New! **SUBJECT:** **NEW VEHICLE RECOMMENDED DELIVERY HOLD Update Prior To Sale 24U11 – Supplement #1**
Certain 2024 Model Year Bronco Vehicles
Key Function Check

REF: **NEW VEHICLE RECOMMENDED DELIVERY HOLD Update Prior To Sale 24U11**
Certain 2024 Model Year Bronco Vehicles with Passive Entry Passive Start (PEPS)
Key Function Check

New! **REASON FOR THIS SUPPLEMENT**

FIGURE 2

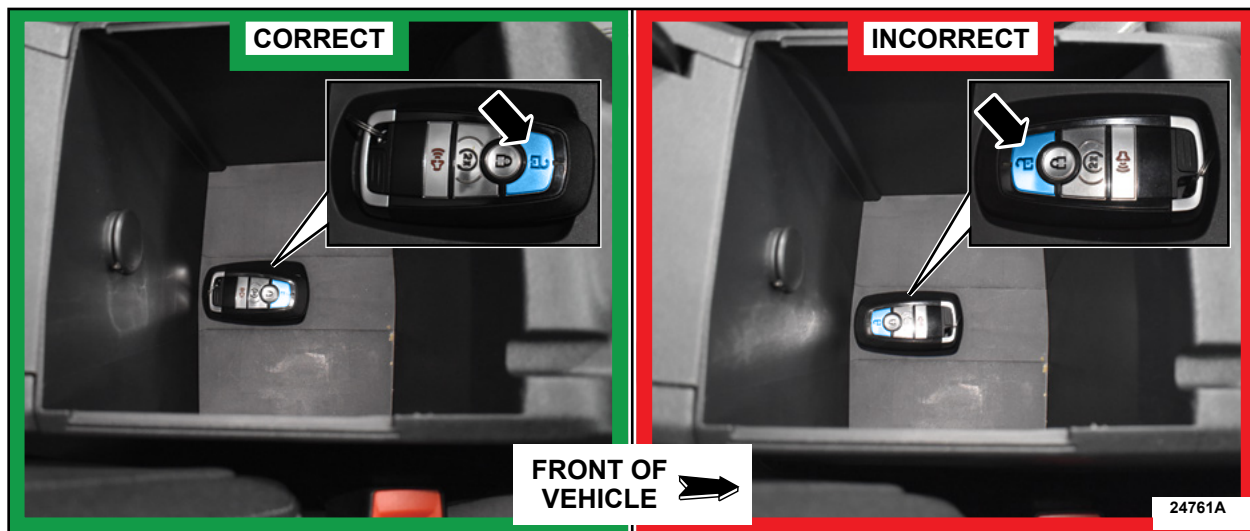
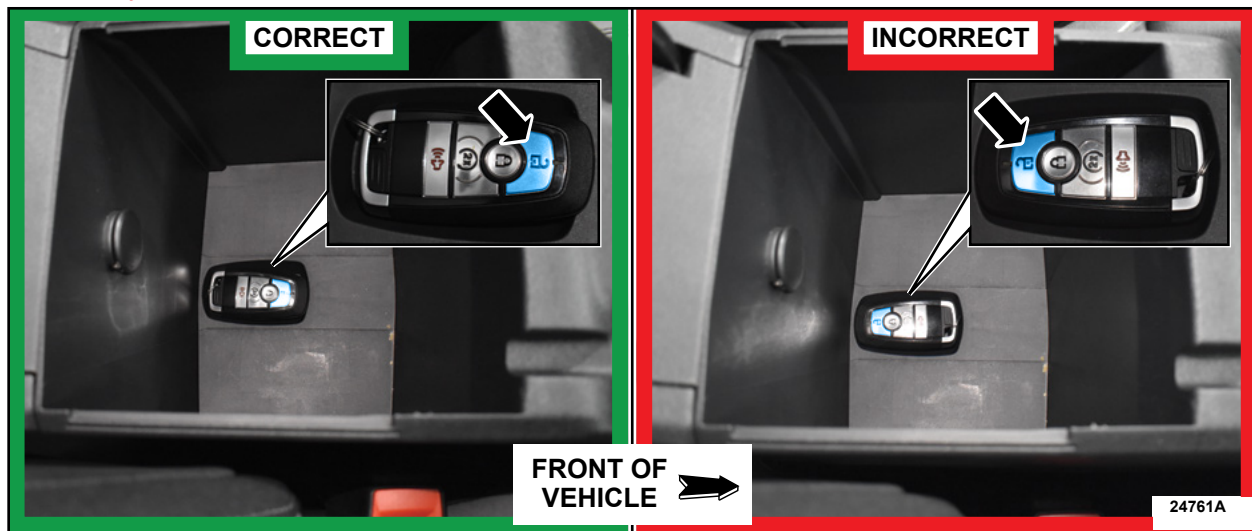
- **Title:** The title has been revised. Vehicles without PEPS are also included.
- **Technical Instructions:** The procedure has been revised by removing the door unlock check, as some vehicles in this program do not have passive entry.
- **Reason For This Program:** Reference to PEPS removed.
- **Service Action:** Reference to door unlock steps for PEPS vehicles removed.

5. From the list on the LH side of the screen, select the **PCM**.
6. From the list on the RH side of the screen, select **Passive Anti-Theft System (PATS) Programming**.
7. Click **RUN**. Follow all on-screen instructions carefully.
8. When prompted to "Select the desired function", select **Erase Keys**. Follow all on-screen instructions carefully.
9. When prompted to "Select the desired function", select **Program Keys**.
10. When prompted, place the key fob that is to be programmed with the unlock button towards the front of the vehicle onto the backup transceiver located in the center console under the rubber mat then select **OK**. See Figure 2.
